PSC Box Beam and PSC Cored Slab Beam Bridges Common Item and Quantity Errors

Example 1 - PSC Box Beam Bridge

BRIDGE SERIAL NO. 145-0052-0
 BRIDGE I.D. NO. 145-01427F-001.78E
 PROJECT P.J. NO. 0015315

BRIDGE NO. 1		GEORGIA	
DEPARTMENT OF TRANSPORTATION			
ENGINEERING DIVISION-OFFICE OF BRIDGES AND STRUCTURES			
PLAN AND ELEVATION			
CR 29 (OLD WEST POINT RD)			
OVER CHATTAHOOCHEE RIVER TRIBUTARY			
HARRIS COUNTY			0015315
SCALE: 1" = 10'-0" (UNLESS OTHERWISE NOTED)		JULY 2017	
DRAWING NO. 35-0001	DESIGNED <u>KNT</u>	CHECKED <u>VMW</u>	REVIEWED <u>DLC/SKG</u>
BRIDGE SHEET 1 OF 13	DRAWN <u>KNT</u>	DESIGN GROUP <u>EJC</u>	APPROVED <u>WMD</u>

SECTION AT INTERMEDIATE BENT SCALE: 3/4" = 1'-0"

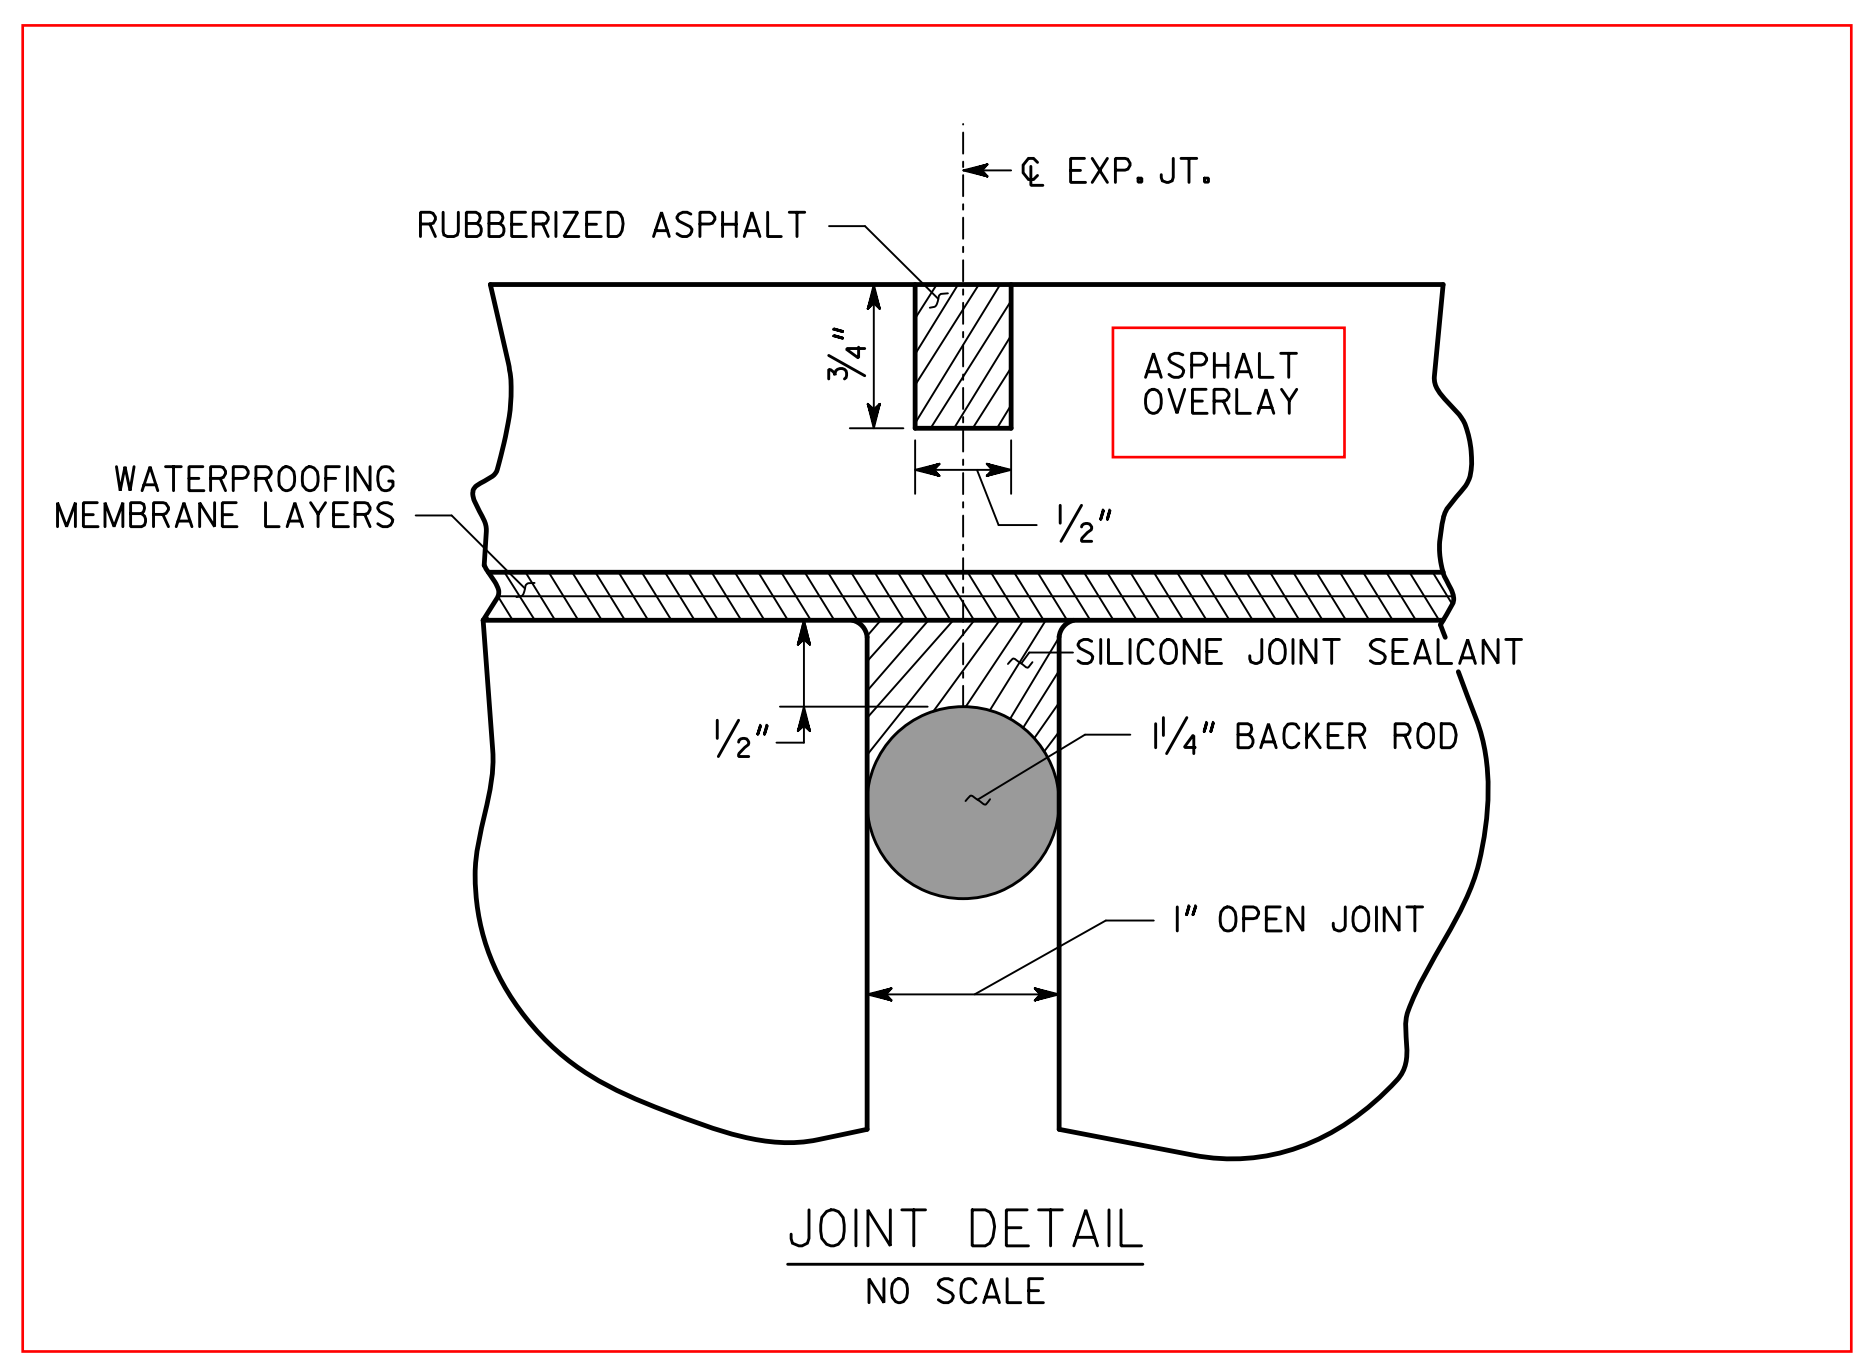
Review all the items outlined in red.
 Notice that the cross slope for this tangent alignment bridge is 2.5%.
 Since the bridge deck is leveled and overlaid the approach slabs are also leveled and overlaid. See the End Bent Joint Detail.
 Roadway cross sections will have to account for cross slope transition to meet the bridge cross slope.
 The Recycled Asphaltic Concrete Surface Course used on the bridge and approach slabs is the same as the roadway and should have the same spread rate. Typically this is either 135 lb/sy for 9.5 mm SP which is 1.25-inch thick or 165 lb/sy for 12.5 mm SP which is 1.5-inch thick. Leveling is used from the top surface of the Box Beams to the bottom of the surface course with the leveling creating the cross slope.
 This project uses 9.5 mm SP thus the leveling thickness using the minimum overlay thicknesses specified this 0.25-inch thick at the gutter line and 4.75-inch thick at the CL.
